TEGHNICAL BULLETIN

SPR2000H SPEEDSHINE with "OHIO" motors

Install motor cover spacers and gaskets. (Kit #600826)

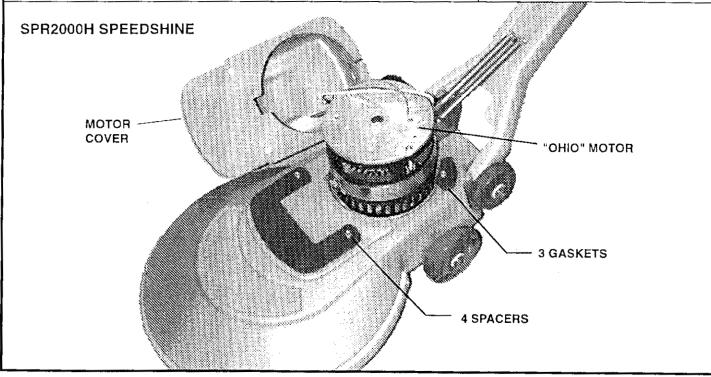
To prevent motor from overheating. Overheated motor may cause rectifiers to fail and/or circuit breakers to trip.

- 1. Remove pad driver.
- 2. Remove motor cover by removing 4 screws from underneath machine.
- 3. Adhere gaskets to machine as shown. Be certain to match up holes before adhering gaskets.
- 4. Insert four spacers into gasket holes as shown.
- 5. Reinstall motor cover. Use longer screws supplied with kit.
- 6. Replace pad driver.
